AMOS SMITH LOT 3

APPLICATION FOR IMPROVEMENT PERMIT
FOR RESIDENTIAL SITE
INDIVIDUAL WATER AND WASTEWATER
SYSTEMS PROGRAM

Re: Amos Smith Road
File: 1774B
Parcel: 113-221-03PO

Re: Amos Smith Road
File: 1775B
Parcel: 113-221-03PO

SOIL/SITE EVALUATION
for ON-SITE WASTEWATER SYSTEM

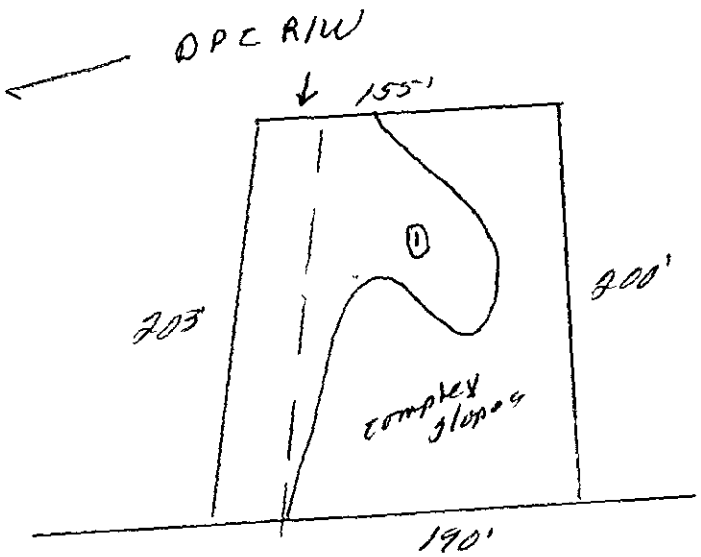
PROFILE #	Slopes 5-10% .1940 LANDSCAPE POSITION/ SLOPE %	HORIZON DEPTH (IN.)	SOIL MORPHOLOGY (.1941) .1941 STRUCTURE/ TEXTURE	SOIL MORPHOLOGY (.1941) .1941 CONSISTENCE/ MINERALOGY	OTHER PROFILE FACTORS 1942 SOIL WETNESS/ COLOR	.1943 SOIL DEPTH	1956 SAPRO CLASS	.1944 RESTR HORIZ	PROFIL CLASS & LTAI
1	LS	0-8"	gr/sl/cl	Fr/SEXP/SS/SP	2.5Y 6/1 @ 20"	37"	N/A	None	US
		8-37"	SBK/C	FI-VFI/EXP/US/US					
2									
3									
4

OTHER FACTORS (.1946):
SITE CLASSIFICATION (.1948): Unsuitable
EVALUATED BY: W.R. Merlin 4-24-97
OTHER(S) PRESENT: LSS

COMMENTS: 1002 Repair

SOIL/SITE EVALUATION
for ON-SITE WASTEWATER SYSTEM

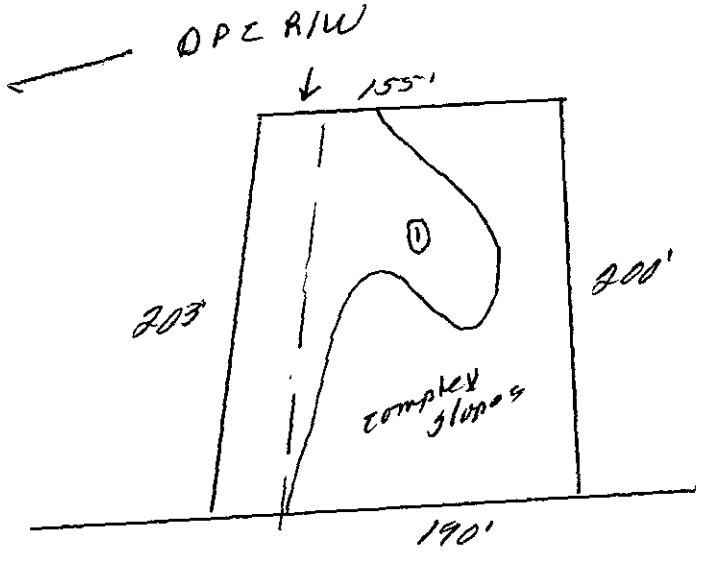
PROFILE #	3 slopes 5-10% .1940 LANDSCAPE POSITION/ SLOPE %	HORIZON DEPTH (IN.)	SOIL MORPHOLOGY (.1941) STRUCTURE/ TEXTURE	SOIL MORPHOLOGY (.1941) CONSISTENCE/ MINERALOGY	OTHER PROFILE FACTORS .1942 SOIL WETNESS/ COLOR	.1943 SOIL DEPTH	.1956 SAPRO CLASS	.1944 RESTR HORIZ	PROFILE CLASS & LTAR
1	LS	0-9"	gr/sCl	Fr/SEXP SS/SP	2.5Y 6/1 @ 20"	37"	N/A	None	US
		9-37"	SBK/C	Fi-VFi/EXP VSS/VS					
2									
3									
4

OTHER FACTORS (.1946):
SITE CLASSIFICATION (.1948): Unsuitable
EVALUATED BY: W.R. Marlin 4-24-97
OTHER(S) PRESENT: LSS

COMMENTS: 100% Repair

SOIL/SITE EVALUATION
for ON-SITE WASTEWATER SYSTEM

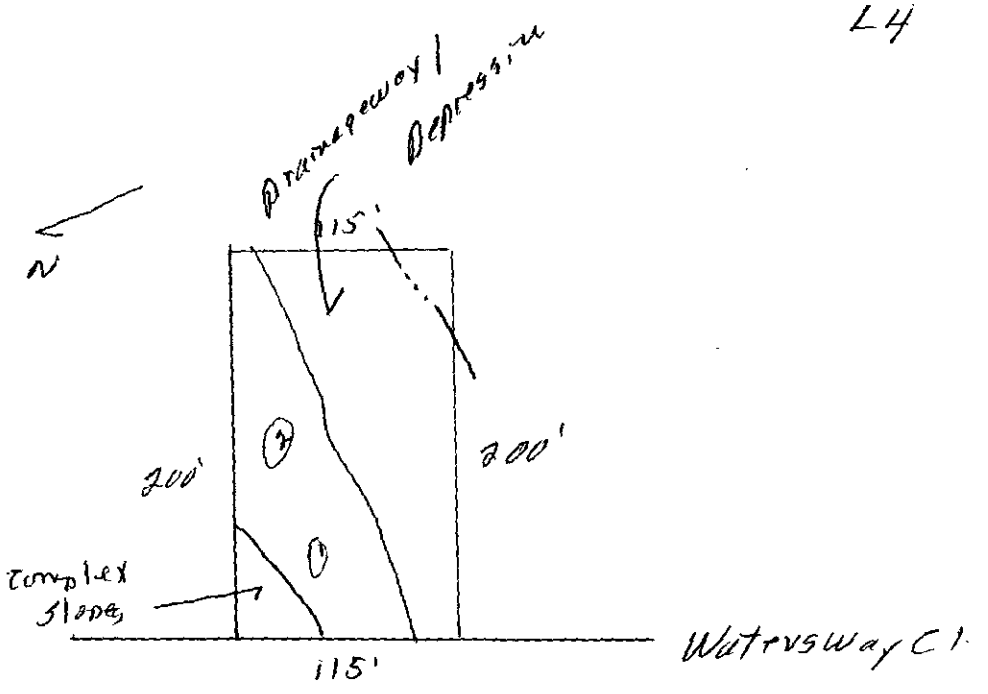
PROFILE #	.1940 LANDSCAPE POSITION/ SLOPE % (Slopes 5-7%)	HORIZON DEPTH (IN.)	SOIL MORPHOLOGY (.1941) .1941 STRUCTURE/ TEXTURE	SOIL MORPHOLOGY (.1941) .1941 CONSISTENCE/ MINERALOGY	OTHER PROFILE FACTORS .1942 SOIL WETNESS/ COLOR	.1943 SOIL DEPTH	.1956 SAPRO CLASS	.1944 RESTR HORIZ	PROFIL CLASS & LTAR
1	LS	0-4"	gr/sl	Fr/SE/Sl/SS/SP	2.5Y 7/1 @ 29"	30"	N/A	None	US
		4-30"	SAN/C	FI-VF/Exp/Sl/Sp					
2	LS	0-9"	gr/sl	Fr/SE/Sl/SS/SP	> 36" to soil wetness	36"	N/A	None	US
		9-36"	SBK/C	FI-VF/Exp/Sl/Sp					
3									
4

OTHER FACTORS (.1946):
SITE CLASSIFICATION (.1948): Unsuitable
EVALUATED BY: W.A. Mauldin - 4-27-97
OTHER(S) PRESENT: LSS

COMMENTS: 100% Repair

SOIL/SITE EVALUATION
for ON-SITE WASTEWATER SYSTEM

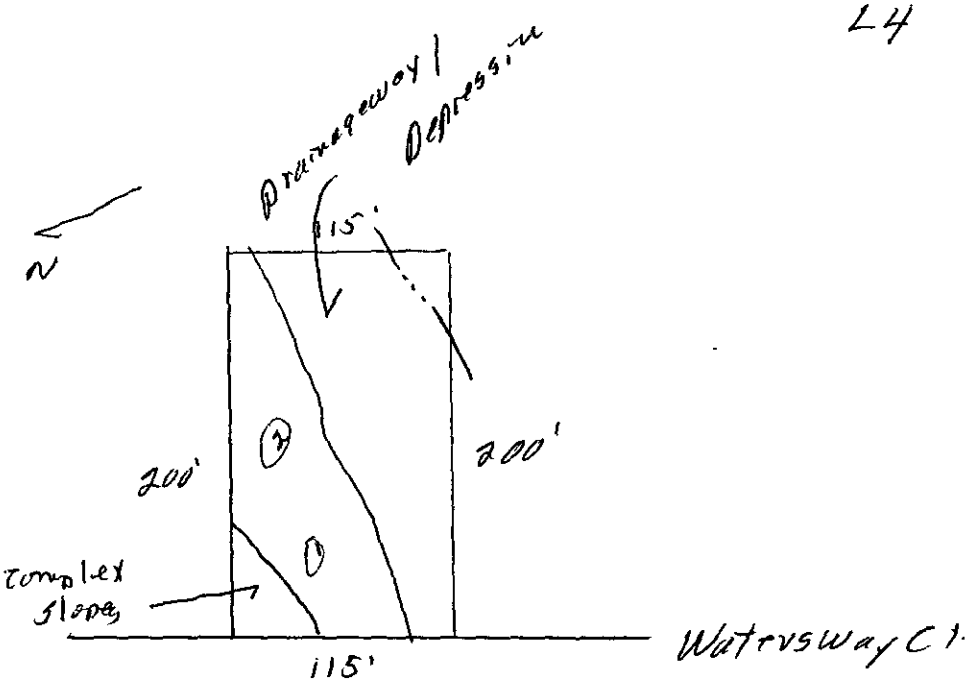
PROFILE #	Slopes 5-7% .1940 LANDSCAPE POSITION/ SLOPE %	HORIZON DEPTH (IN.)	SOIL MORPHOLOGY (.1941) .1941 STRUCTURE/ TEXTURE	SOIL MORPHOLOGY (.1941) .1941 CONSISTENCE/ MINERALOGY	OTHER PROFILE FACTORS .1942 SOIL WETNESS/ COLOR	OTHER PROFILE FACTORS .1943 SOIL DEPTH	OTHER PROFILE FACTORS .1956 SAPRO CLASS	OTHER PROFILE FACTORS .1944 RESTR HORIZ	PROFILE CLASS & LTAR
1	LS	0-4"	gr/ sl	Fr/ SE X P/SS/SP	2.5Y 7/1 @ 29"	30"	N/A	None	US
		4-30"	SBK/ C	Fi-VFi/ EXP/SS/P					
2	LS	0-9"	gr/ sl	Fr/ SE X P/SS/SP	> 36" TO soil wetness	36"	N/A	None	US
		9-36"	SBK/ C	Fi-VFi/ EXP/SS/P					
3									
4

OTHER FACTORS (.1946):
SITE CLASSIFICATION (.1948): Unsuitable
EVALUATED BY: W.A. Mauldin - 4-23-97
OTHER(S) PRESENT: LSS

COMMENTS: 100% Repair
